DOC16/237098-1
SSD 6693

Rye Park Wind Farm Response to Submissions (RTS) and Amended Environmental Impact Statement (EIS)

Rye Park Wind Farm Biodiversity Assessment Addendum (BAA)

Maps 1A and B - Turbine 125

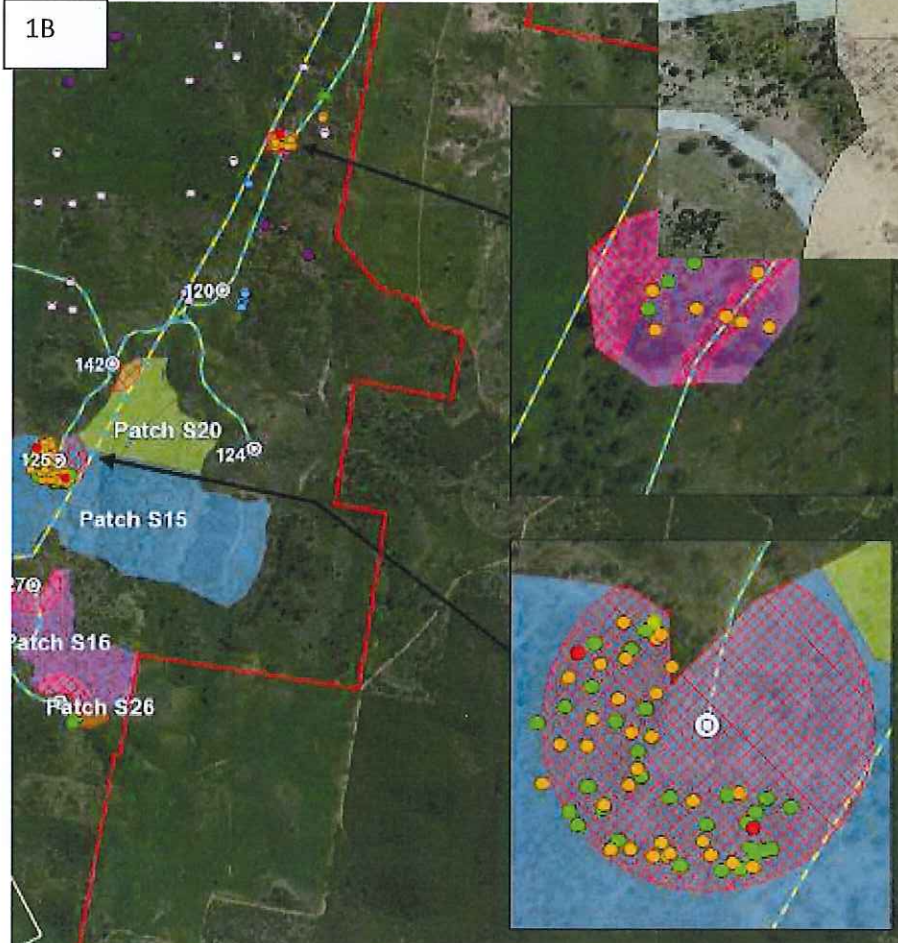
OEH does not endorse the location of this turbine and we have previously advised that this will have a significant impact on biodiversity values.

Patch S15 has one of the highest HBT densities recorded in the study area and the current location will have a very high impact on HBTs. This turbine has been moved a bit in the latest infrastructure layout, but not enough to avoid unnecessary impact on HBTs and HCV woodland.

OEH recommends that this turbine be removed or moved, as described here.

OEH further recommends that the HCV vegetation in this patch should be excised from the micrositing corridor.

Maps 2A and B – turbine 96

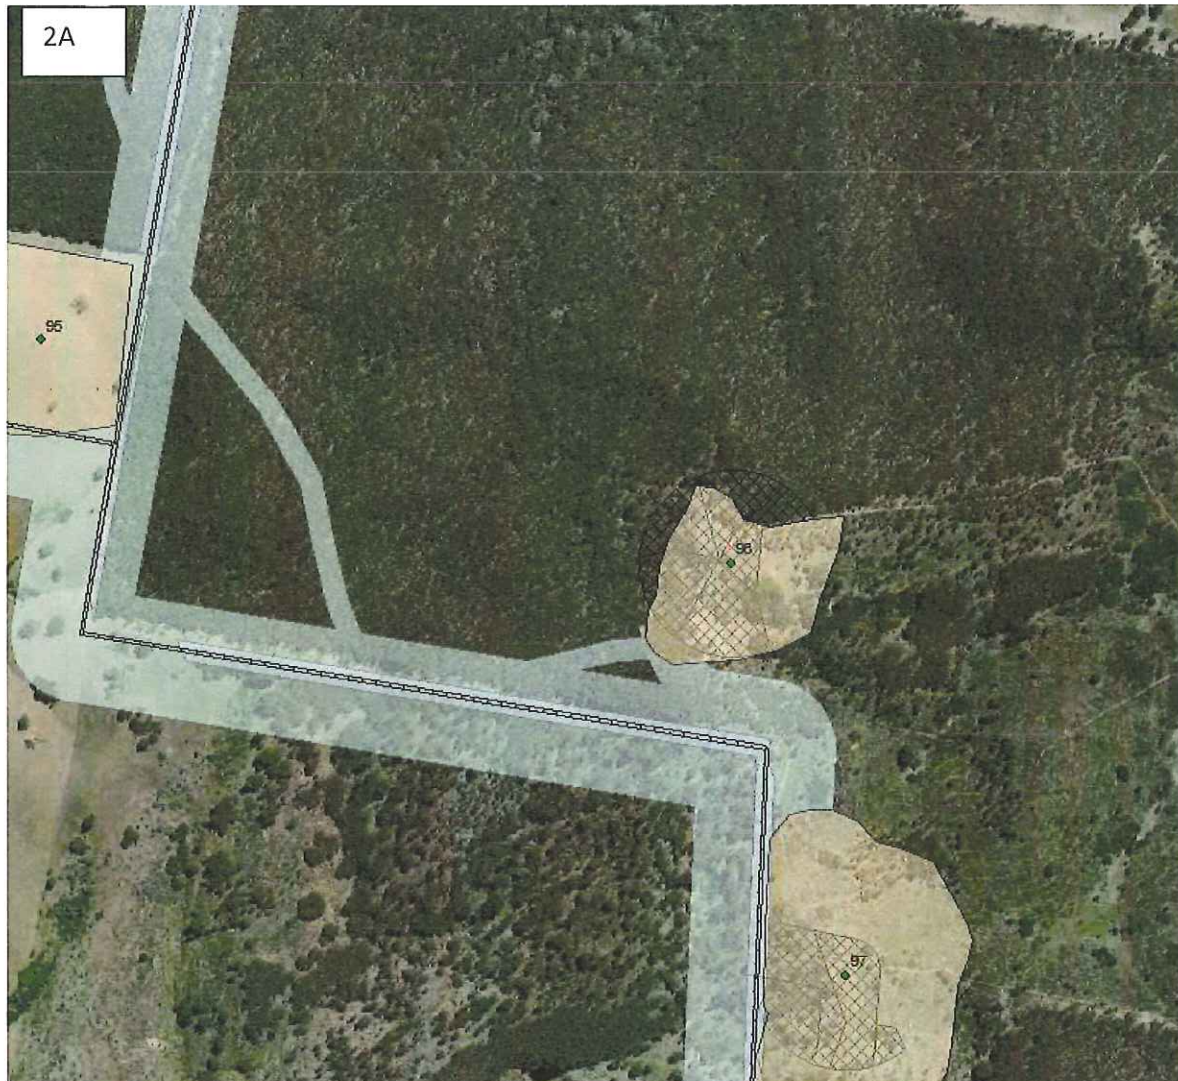
OEH has previously advised that we do not endorse the location of turbine 96. This turbine would be too close to the vegetation canopy due to the slope of the land, thereby having an unacceptable impact on avifauna. OEH recommends that this turbine be deleted.

Maps 3A and B – turbines 150 and 80

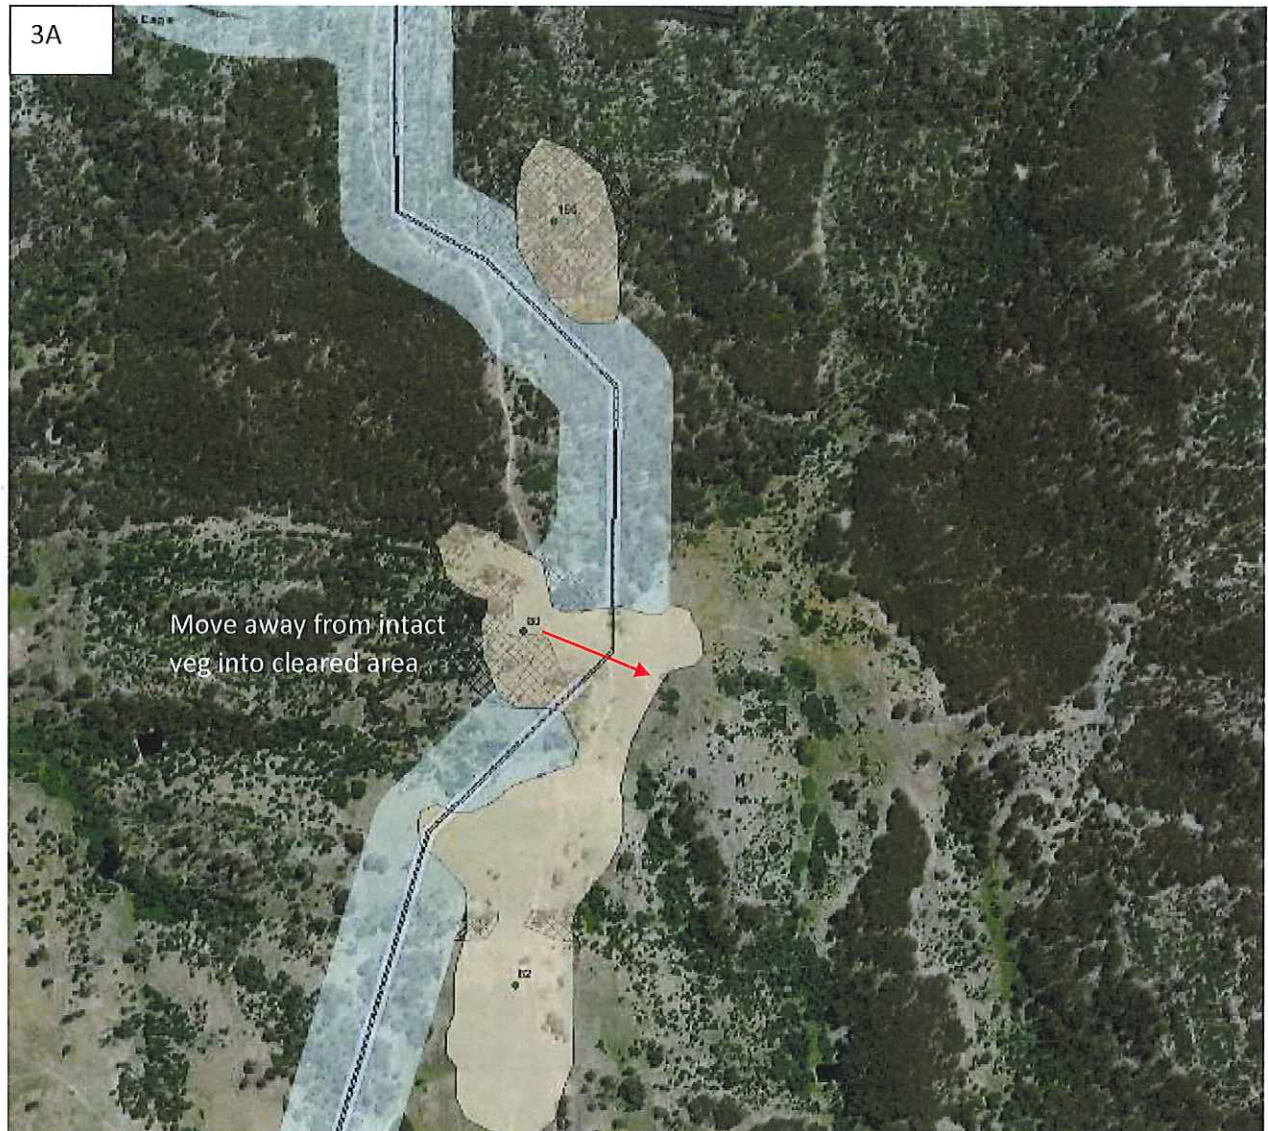
Remove 150 - OEH has previously queried why this new turbine was placed in the middle of an intact patch of Scribbly Gum forest (as mapped in the BAA). This patch (S10) contains a Koala record.

Move 80 - microsite away from edge of forest and HBTs.

There is a koala record in this intact patch of Scribbly Gum forest

Maps 4A and B – mapping of forest adjacent to turbine 48 and HBT assessment

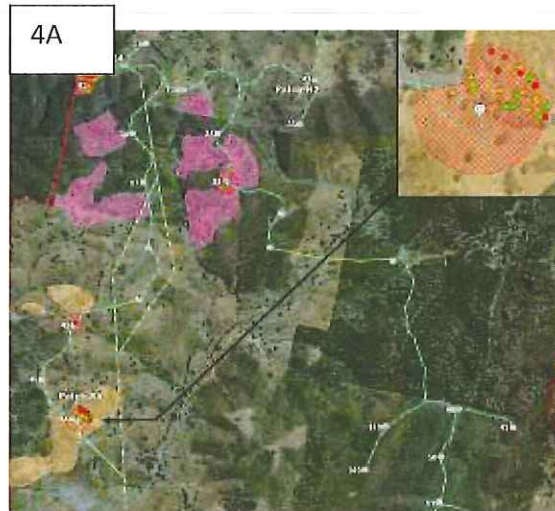
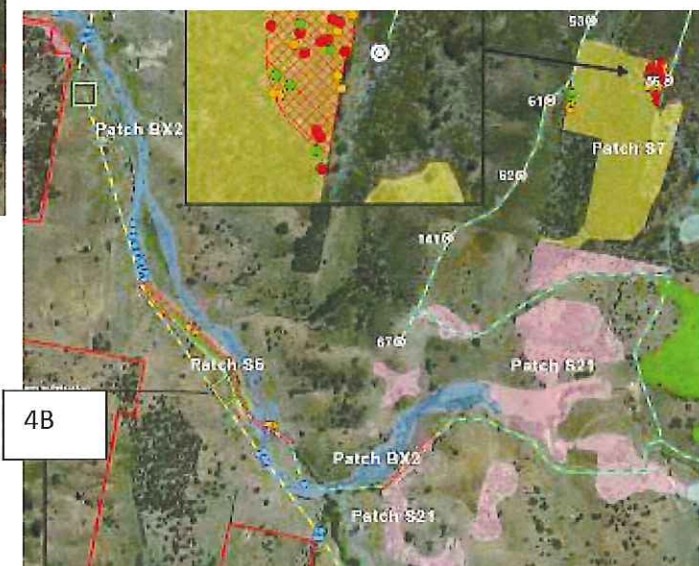
OEH requests clarification of the mapping and impact on the forest adjacent to turbine 48.

The BA addendum (page F-IV) describes the large area of good condition forest adjacent to turbine 48 as: “Mixed age forest with high numbers of HBTs. No verification conducted. Unable to access Turbine 48 (Patch 6) and extrapolation of Patch 7 results considered appropriate as a worst case.” This indicates that the high concentration of HBTs mapped in patch S7 will be extrapolated to patch S6. However the forest is not mapped as a patch in the HBT survey maps, as shown below in map 4A. The area was apparently surveyed for Koala and Crimson Spider Orchid, and is referred to as being similar to Patch S7. There is a kilometre of new road being put through the middle of it, and turbines 48 and 49 at its edge.

The HBT survey map 2 (4A, left) shows no patch mapping for the good condition Scribbly Gum forest adjacent to turbine 48.

The HBT survey map 3 (4B, right) shows a sliver of land along a road as being patch S6.

This excerpt from the HBT survey data table (from page F-XX in the BAA) clearly shows that patch 6 is the sliver along the road (as shown in 4B), not the large area of forest adjacent to turbine 48 (as shown in 4A).

Maps 5A, B and C – turbines 85, 86, 87, 90 and 93

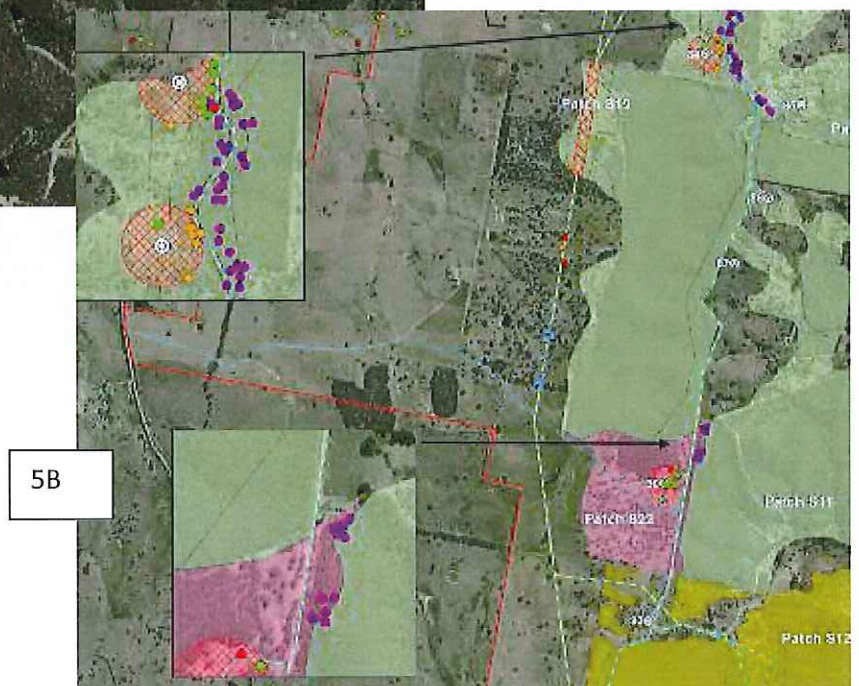
These turbines will have a large impact on HBTs, and are all located right on the edge of intact, good quality HCV remnant forest vegetation. Three of them (85, 87, 90) were listed in the top 15 turbines having greatest potential impact on surrounding trees in the HBT assessment. OEHL recommends that turbine 85 should be moved further from the edge of intact veg, in order to reduce the project's

impact on HBTs. Moving turbines 86 and 87 away from the forest edge and avoiding HBTs would also reduce the impact and require less offset.

OEH recommends that turbine 90 be removed. It would not be possible to microsite it as there is HCV forest on three sides, and a Wedge-tailed Eagle nest 500m buffer on the other side. As turbine 90 cannot be micrositied into the WTE buffer, it should be excised from the micrositing corridor.

Turbine 93 cannot be micrositied into the WTE buffer, so the buffer should be excised from the micrositing corridor.

Maps 7A and B – turbine 32

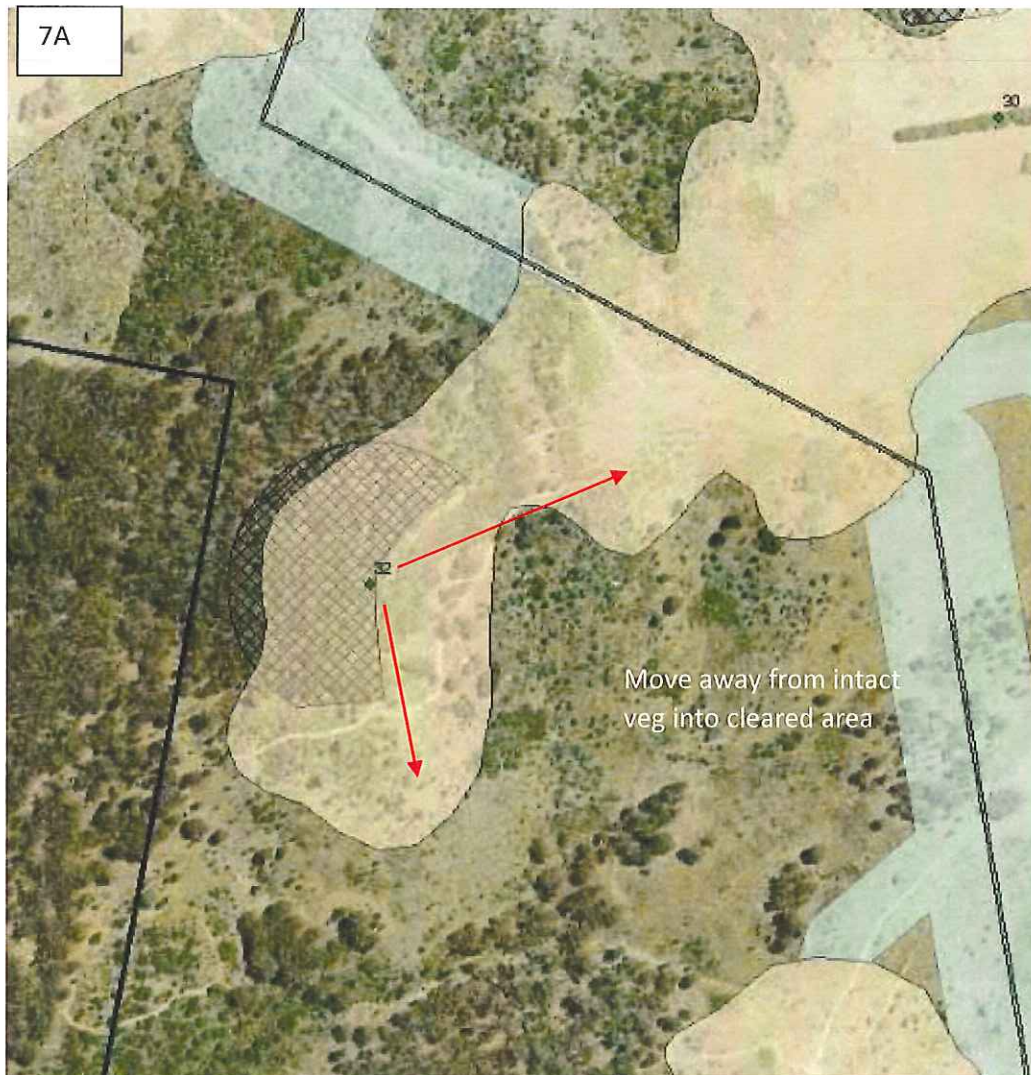
Patch S4 is mixed age mature Scribbly Gum forest with high densities of HBTs. This turbine should be moved into cleared area away from the forest edge. The high constraint forest should be removed from the micro-siting corridor.

Maps 8A and B – turbine 38

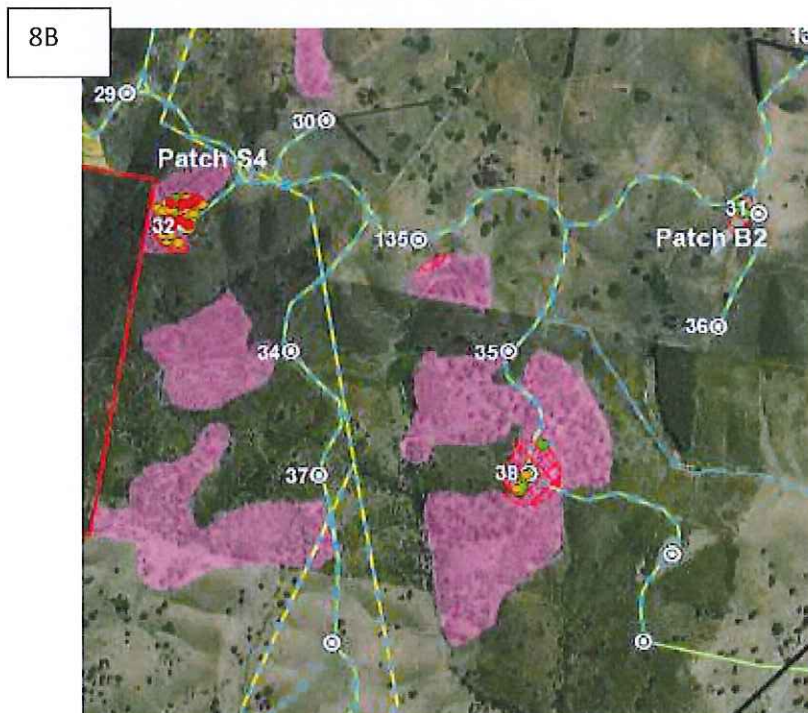
OEH recommends moving this turbine out of the mixed age mature forest with a high density of HBTs. This good condition veg should be excised from the microsinning corridor.

Maps 9A and B - Turbine 56 and microsiniting corridor between turbines 53 and 61

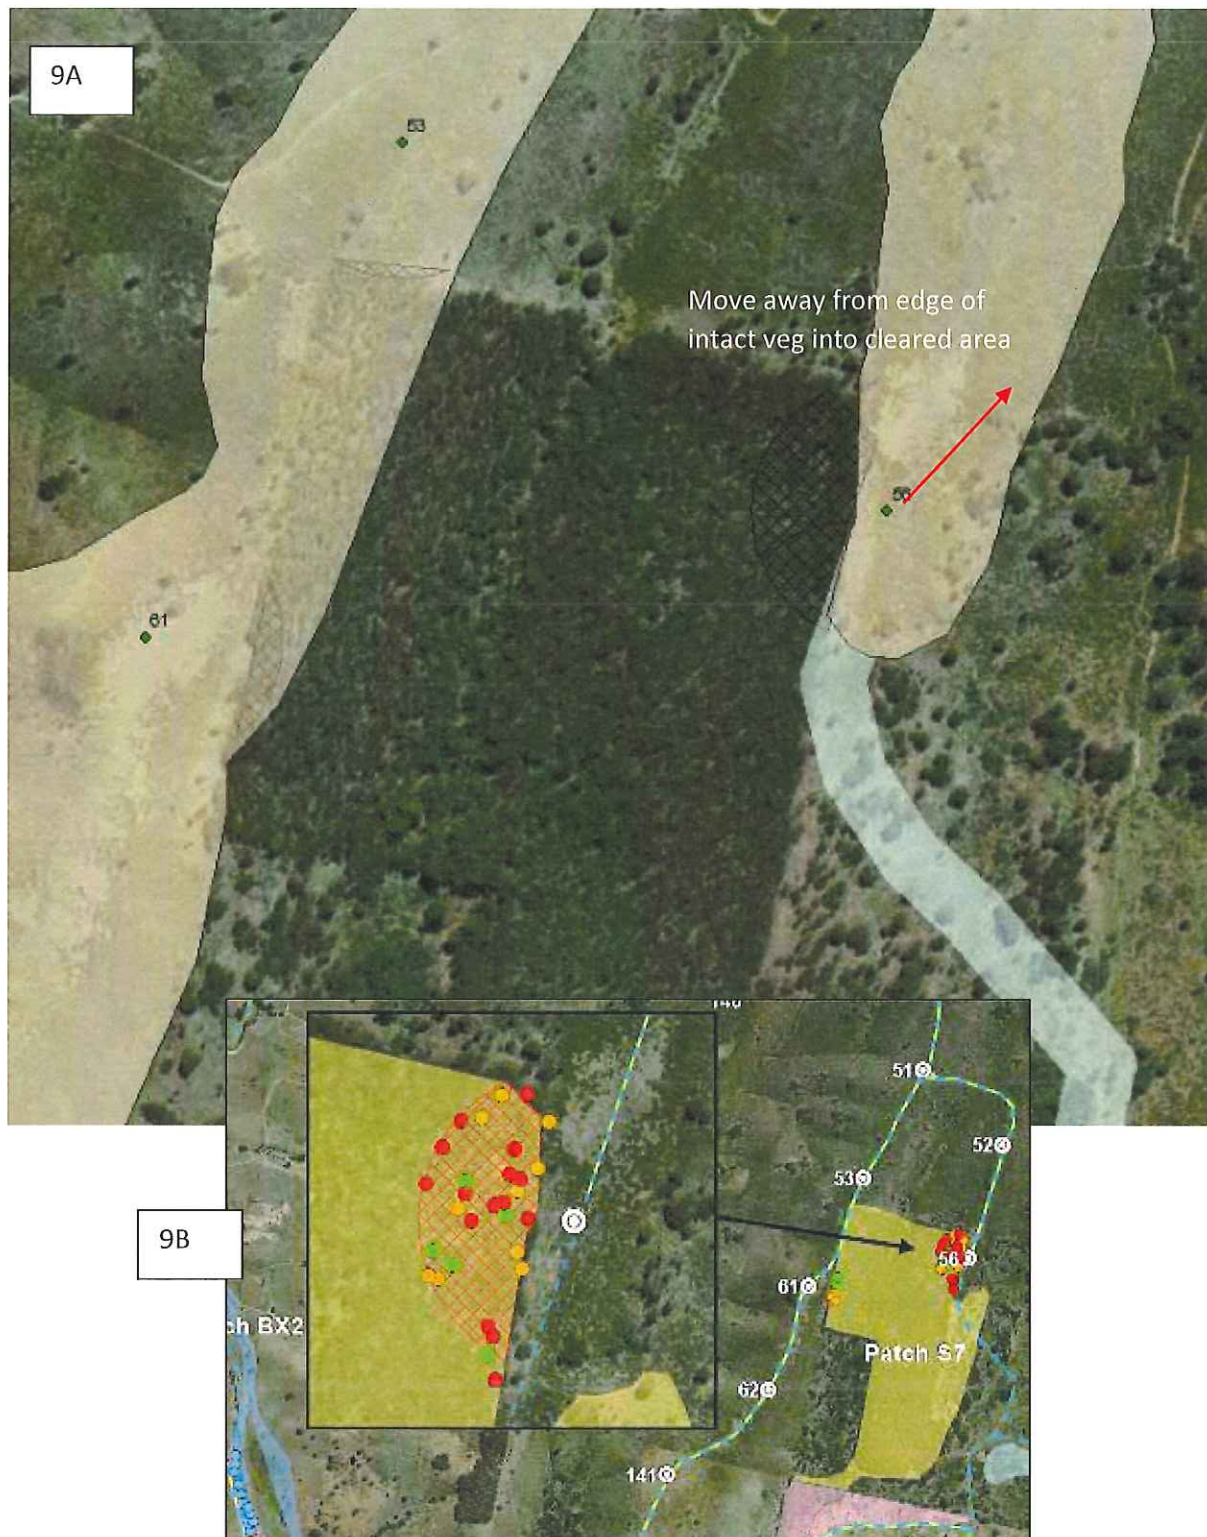
Turbine 56 impacts on a large number of HBT and good condition scribbly gum forest. OEH notes that this turbine has been moved, but its new location is still impacting a large number of HBT. OEH recommends that the turbine be moved away from the forest edge into the microsiniting corridor so that HBT are not impacted.

The microsiniting corridor between 53 and 61 should be adjusted to exclude the intact forest.

Maps 12A and B - Turbine 144

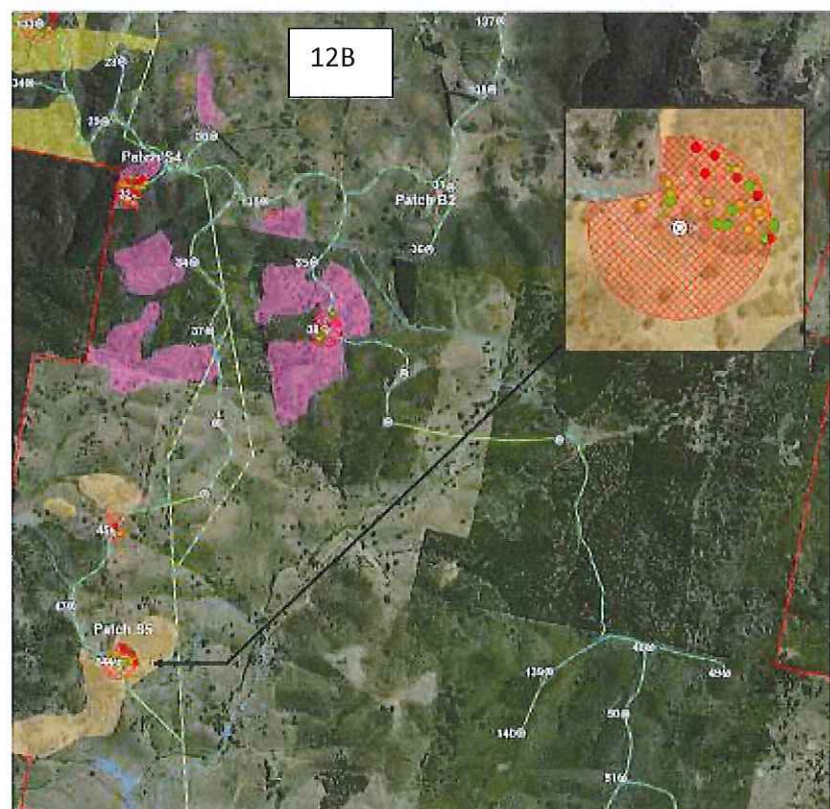
Turbine 144 will impact on a high number of HBTs. Areas of intact remnant forest should be excised from the microsite corridor.

Map 13B – turbine 16

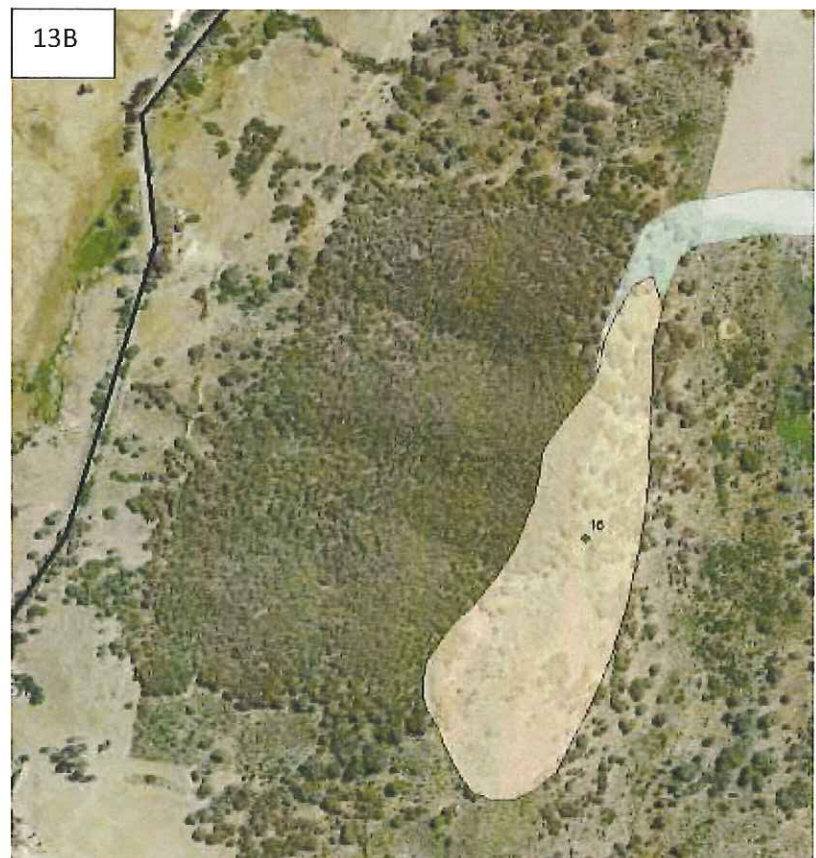
OEH has previously asked for confirmation of the veg identification at 16. It is mapped as Sifton Bush shrubland but doesn't look like other areas mapped as Sifton Bush on the aerial image. There are definitely trees so it can't be just shrubland.

It was highlighted as one of the turbines with the highest number of surrounding trees in the HBT assessment - yet the patch has not been mapped and no assessment of impact is provided.

Why is the microsinning footprint so big?
